FOR DA	с		
JOB TITLE				
Christ Church				
Hampstead				
DRAWING TITLE				
South Elevation				
Existing Condition				
JOB No	DWG No	REV		
537A	SU03	-		
DRAWN BY	SCALE (AT A1)	DATE		
JMc	1:100 (1:200@A3	3) Dec14

RICHARD GRIFFITHS ARCHITECTS

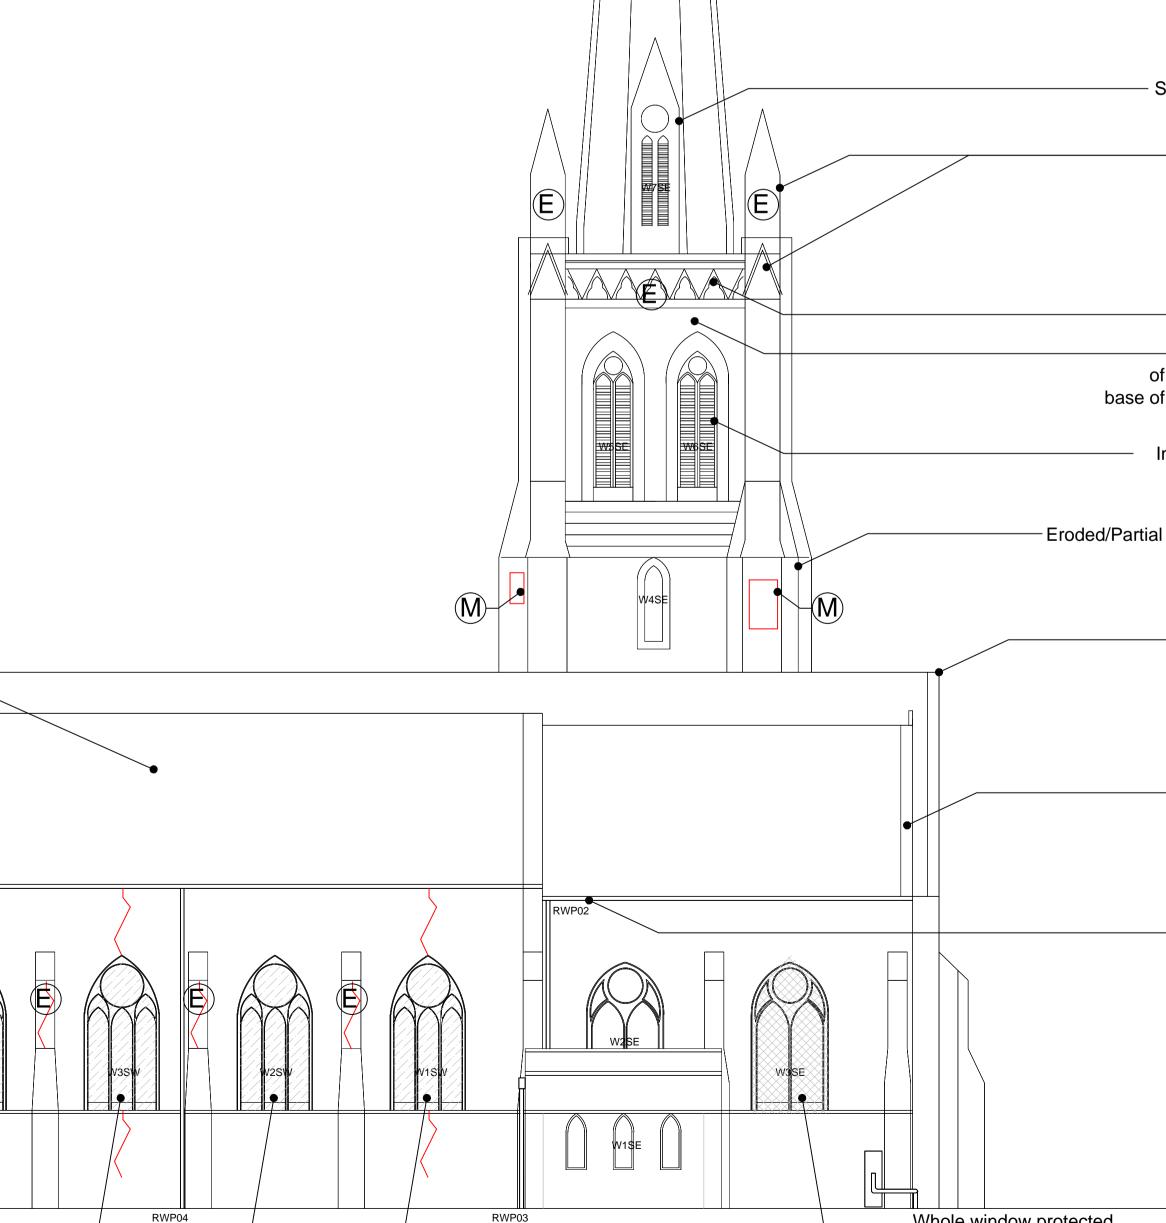
All areas to be DOFF cleaned early in contract. Conservation Architect to explore stonework and re survey after cleaning and identify any further cracking and repairs.

From initial condition survey allow for 75% of ashlar to be repointed and approx 60% repointing to ragstone in lime mortar in accordance with RGA specification.

Repointing to include all elevations, all sky facing surfaces, all buttresses, open joints around downpipes, all main cornices along gutters, all copings, parapets and pinnacles.Rake out loose and cement mortar, re point 100% with lime mortar in accordance with RGA specification.

Re survey previous stone indents after cleaning to confirm if structurally sound. If acceptable aesthetically leave in situ.

Stone details; pinnacles, molded copings and crosses to be cleaned and repaired by approved conservator <u>not</u> the contractor. All repairs shown are provisional and subject to inspection and recommendations by conservator on site.

Full stone replacement schedule to be completed following scaffolding erection and stone cleaning.

Remove existing discolored polycarbonate panels or mesh panel and replace with black stainless steel grilles set out in each individual light.

Clean all plain glass windows in situ.

For leaded glass and stain glass, where possible clean and repair insitu, otherwise remove and repair in workshop. If remove, install a temporary board in light. If replacement lead required, retain as much as possible of existing lead. Replace broken quarries and refix to ferramenta with copper wire.

Staining to stonework on tower above window

Parapets, copings and pinnacles eroded, missing pieces of stone and at risk of falling

Open joints to parapet. Stone replacement to confirmed on closer inspection.

Slate tiles to drain water from perimeter of parapet are cracked and loose. Outlets from base of parapet are in asphalt and in poor condition.

Investigate condition of belfry windows further after cleaning

- Eroded/Partial missing stone to ragstone on tower buttress.

Missing stone cross

Copings eroded and renewed in concrete. Open joints and loose lead flashing on inner face of coping.

Gutter and flashing in poor condition.
 Leaf guard missing, hopper overflowing and causing water damage to stone below DO NOT SCALE FROM THIS DRAWING DRAWING TO BE READ IN CONJUNCTION WITH ALL OTHER ARCHITECT'S AND ENGINEER'S CONTRACT DRAWING & SPECIFICATIONS. ANY DISCREPANCIES MUST BE BROUGHT TO THE ATTENTION OF THE ARCHITECT IMMEDIATELY. THE CONTRACTOR MUST VERIFY ALL DIMENSIONS BY SITE MEASUREMENT BEFORE ORDERING MATERIALS OR MANUFACTURING COMPONENTS.

Due to limited roof access, inspection undertaken from ground level and tower parapet. Carry out a closer roof inspection, by scaffolding, to ascertain any repairs required to slates, battens, underlay, gutters and flashing's. Replace slates and lead flashing to all areas of roof as RGA condition survey and specification and LSA recommendations.
